Sunnyvale East and West Channels Flood Protection Project

Final Environmental Impact Report

August 2014

Santa Clara Valley
Water District SM

As a result of this change, **Figure 2-3g** has been updated to indicate that a 170-foot reach of the Sunnyvale East Channel between the Union Pacific Railroad/Caltrain tracks and Kifer Road will be improved with rock slope protection on the bed only.

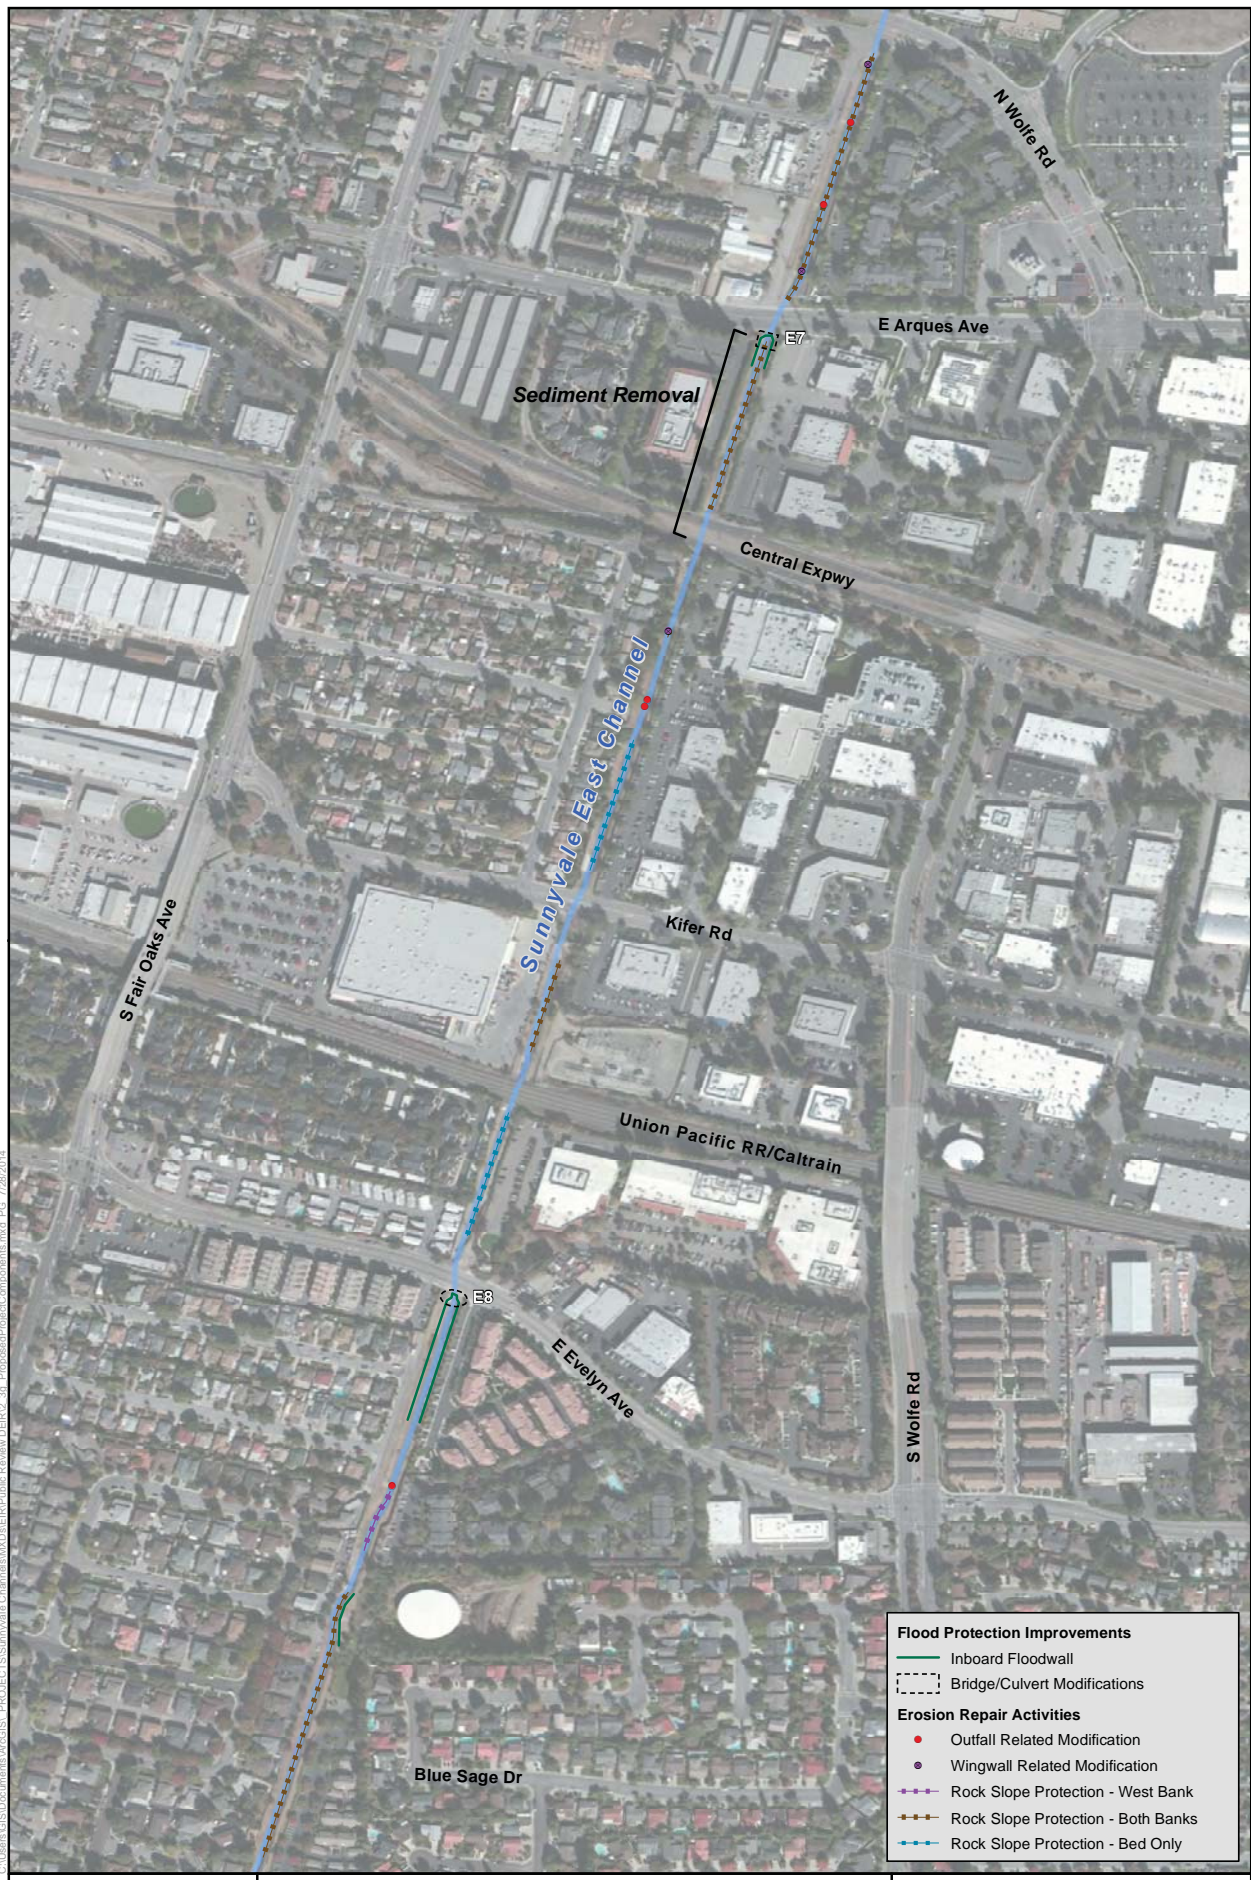
An additional area of rock slope protection has been added to the Proposed Project. A 170-foot reach of the Sunnyvale East Channel between the Union Pacific Railroad/Caltrain tracks and Kifer Road will be improved with rock slope protection on the bed only. Approximately 160 cubic yards of rock fill will be added over approximately 1,700 square feet in this reach. This channel improvement will align with the rock slope protection on the banks which is already identified for this reach. This new rock slope protection site would not substantially change the estimated construction timing, construction equipment use, or quantity of materials imported for the Project.
